APPENDIX J
: INFORMATION OF CLASS II PERMISSIVE CHANGE

This information is to show compliance with FCC regulation Sec. 2.1043 and to be treated as Class II permissive change.

EUT Type: RF Transmitter Universal Remote Control
Model No.: MX-350
FCC ID.: OZ5URC200
Applicant: OHSUNG ELECTRONICS CO.,LTD
Trade Name: Universal Remote Control

< Before >

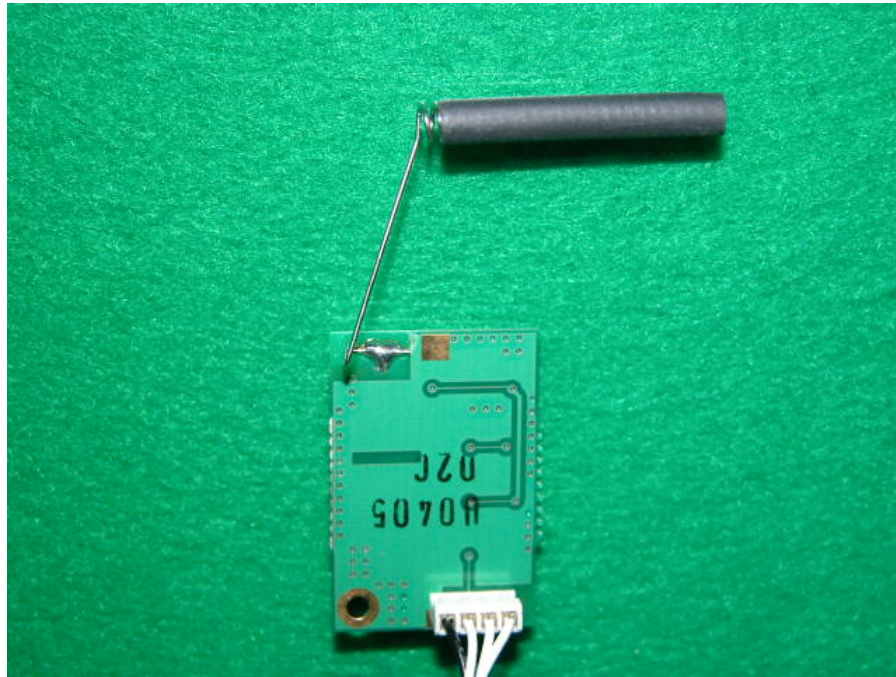
- 1) Added a current stabilization circuit

<Before >

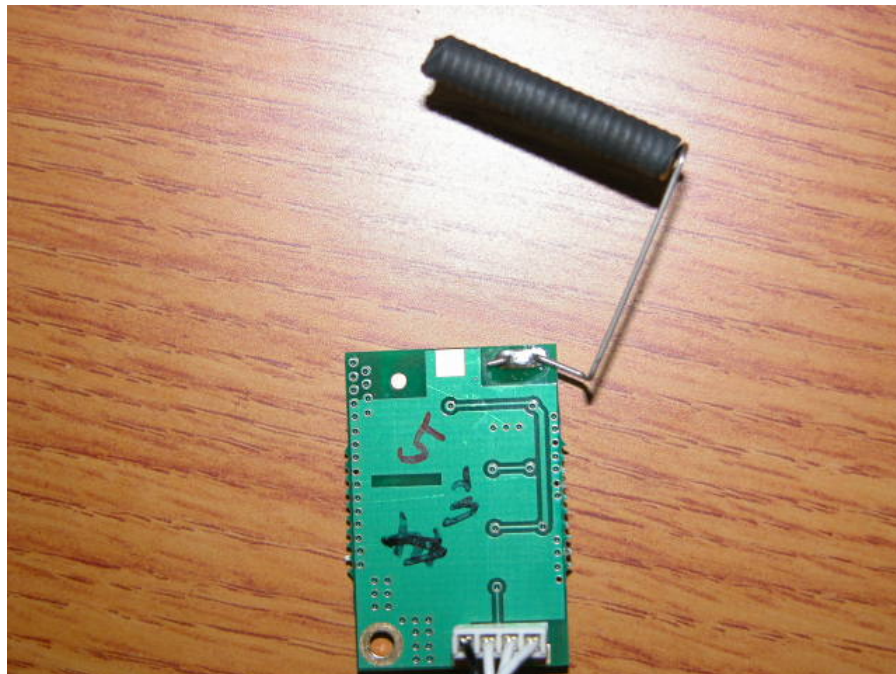
2. Changed the shape and the location of internal antenna
